Re: IHOP Restaurant, 10605 Central Ave NE Grading Plan
Engineer's Stamp date 8-4-09 (L21/D040)

SUBJECT: IHOP RESTAURANT
10605 Central Ave NE
L-21 – D040

Re: IHOP Resturant
10605 Central NE
Permanent Certificate of Occupancy – Transportation Development
Engineer's Stamp dated 12-22-09 (L-21/D040)

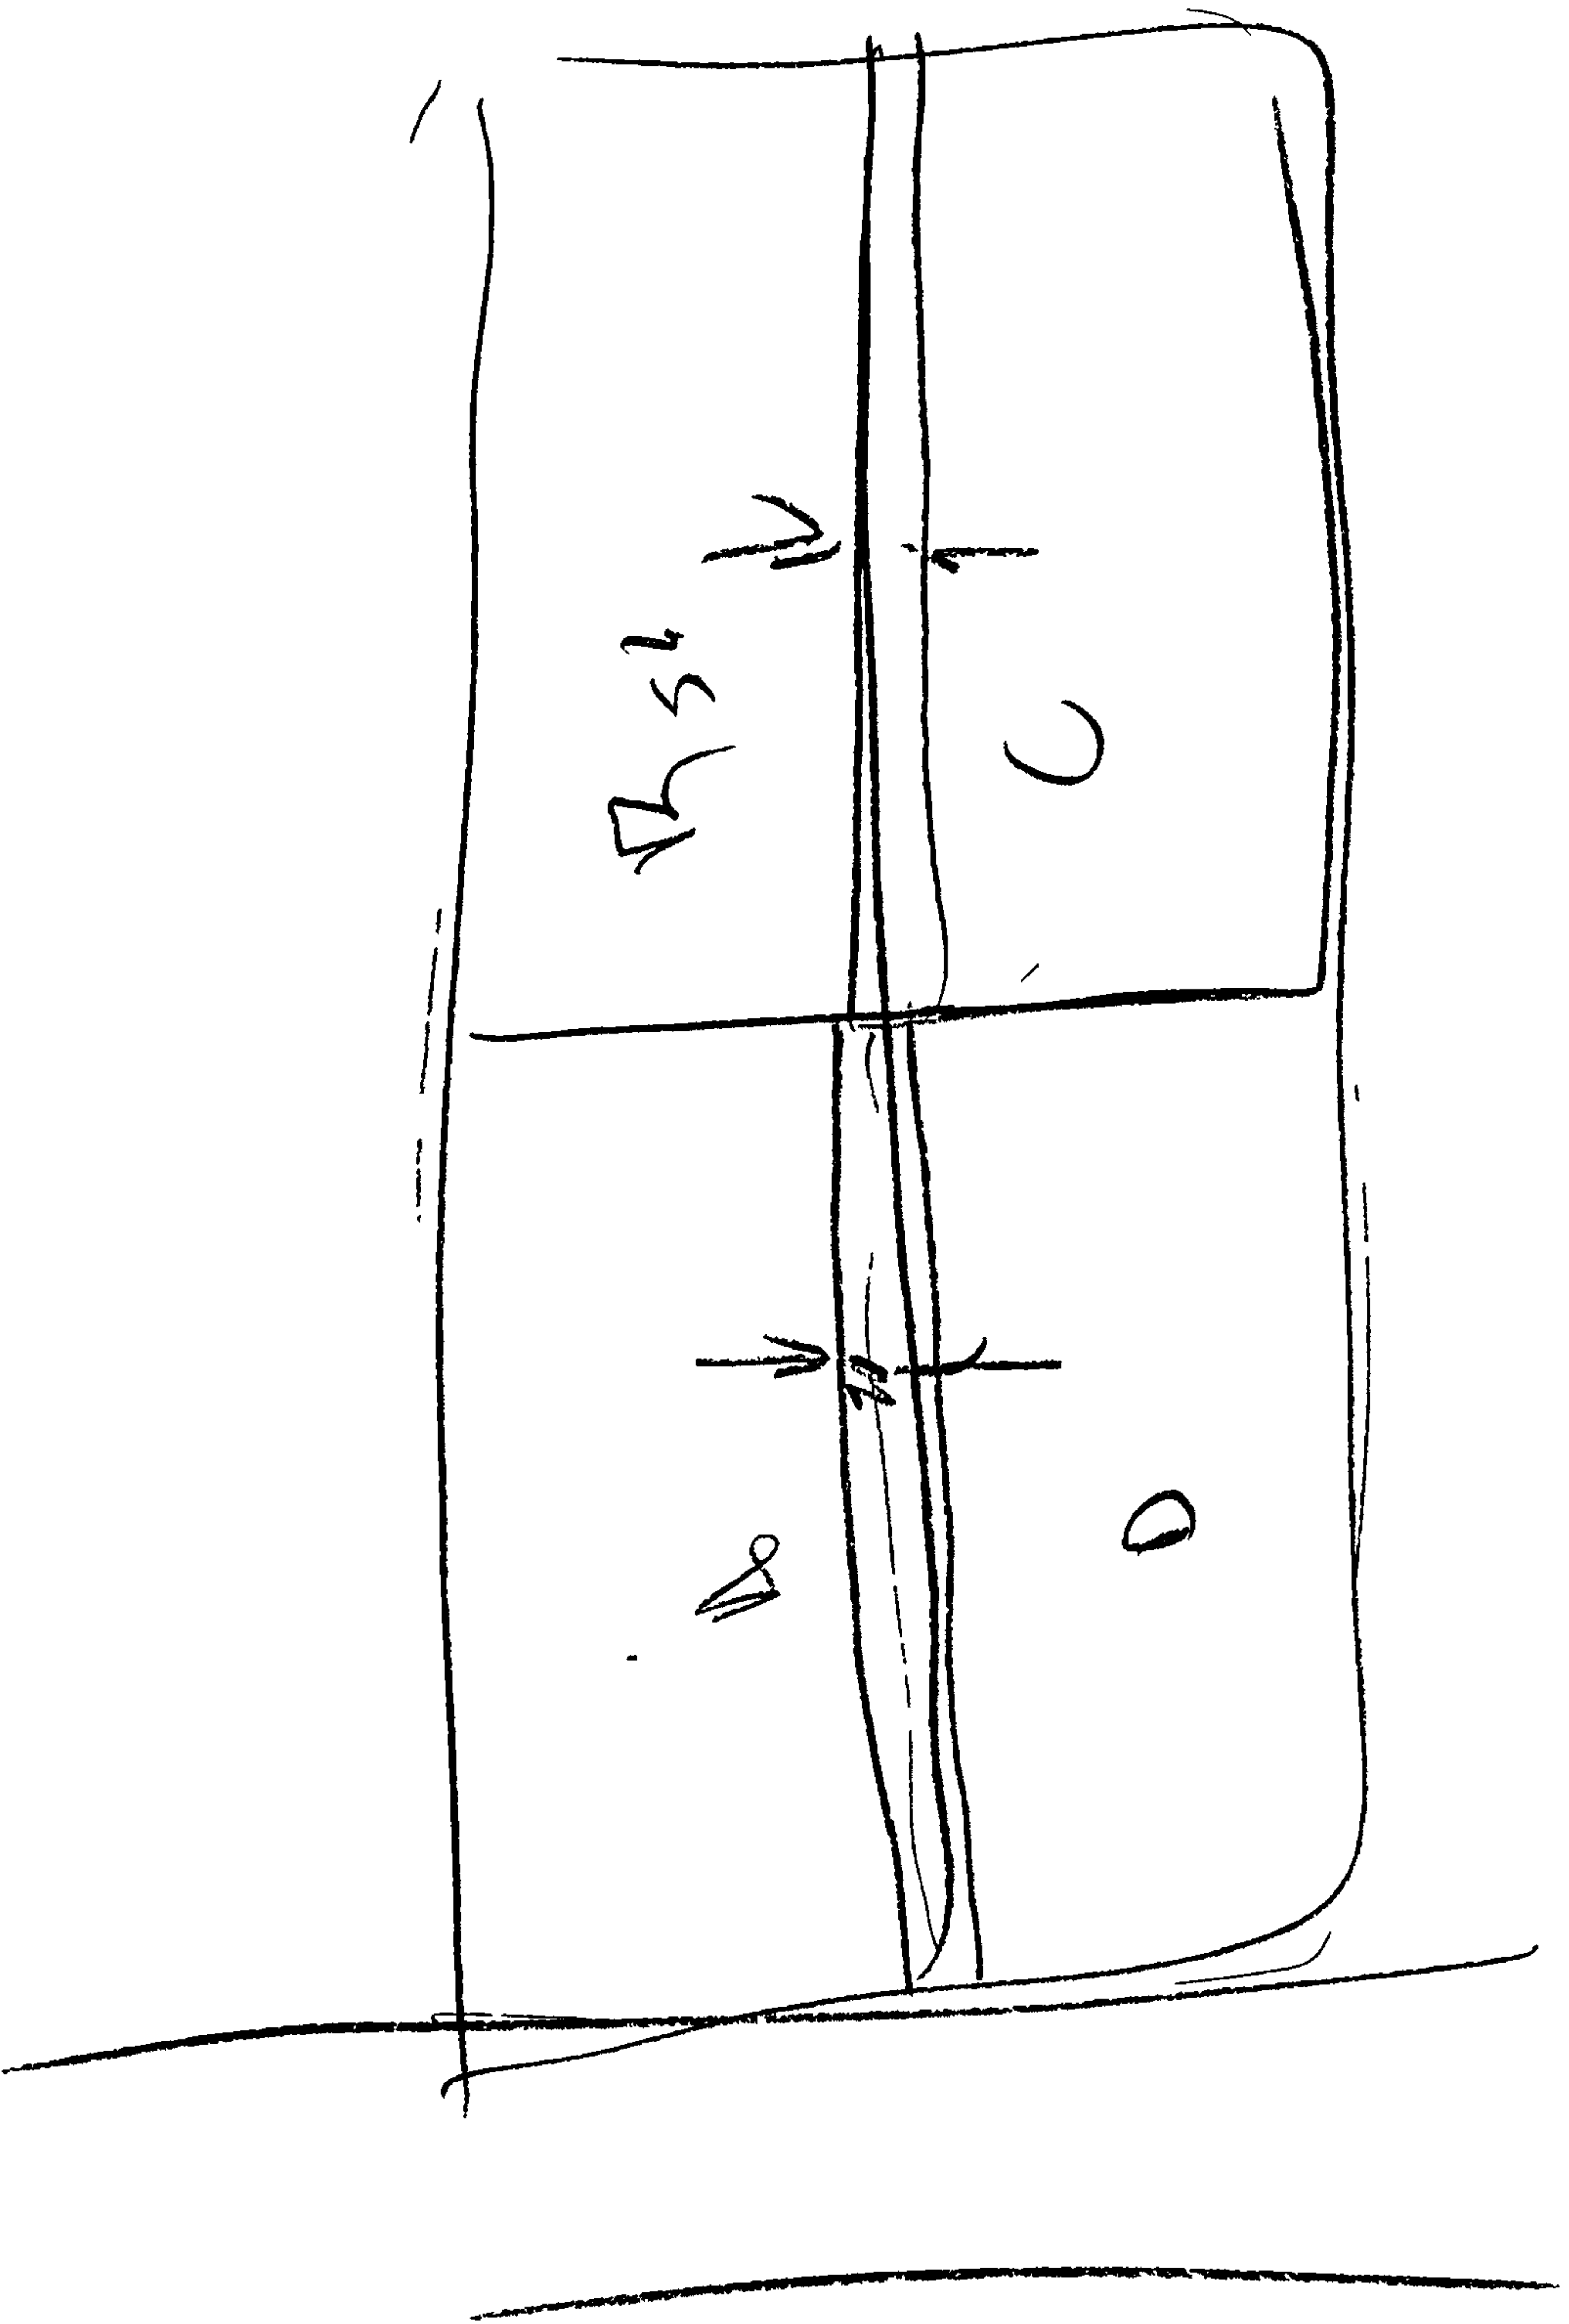
- ✓ 1. Your crest elevation is lower than your water surface elevation. Therefore, over spill will occur before the 100-year water surface elevation will reach maximum elevation.
- ✓ 2. Please include the Weir calculations with your resubmittal.
- ✓ 3. You will need to include the six notes and sign-off block from the S.O. 19 format on the plan drawing. Also, you will need to include the C.O.A. spec. No. for the proposed connection to the back of the existing inlet.
- ✓ 4. Fencing must be provided around the ponding area.
- ✓ 5. Include computation showing your Riser design and required discharge holes.
- ✓ 6. Identify how much off-site flows are entering the site (quantify separately).
- ✓ 7. Computations showing how much ponding area you are providing within your proposed pond.

Comment 1. The proposed pond has been designed with an overflow weir section located on the west property line. Two(2)-1/2 hp submersible pumps will pump water from the pond to an existing drop inlet on Central Ave. The overflow weir section is at elevation 5472.5. The pond will retain a volume equivalent to the future condition 100-Year 24-Hour rainfall volume and discharge it to the Central Ave. Storm Drain with a maximum water surface elevation of 5472.5 (See Attached AHYMO Summary). The remaining off-site water will then be discharged as sheet flow over the overflow weir section and onto the adjacent lot at a flow rate slightly less than the existing condition flow rate.

Comment 2. See grading and drainage plan

Comment 3. See grading and drainage plan

Comment 5. Enclosed with this letter is the rating curve for the riser that will be utilized in our design.

Comment 9. The proposed pumps will drain the pond in 15.50 hours.
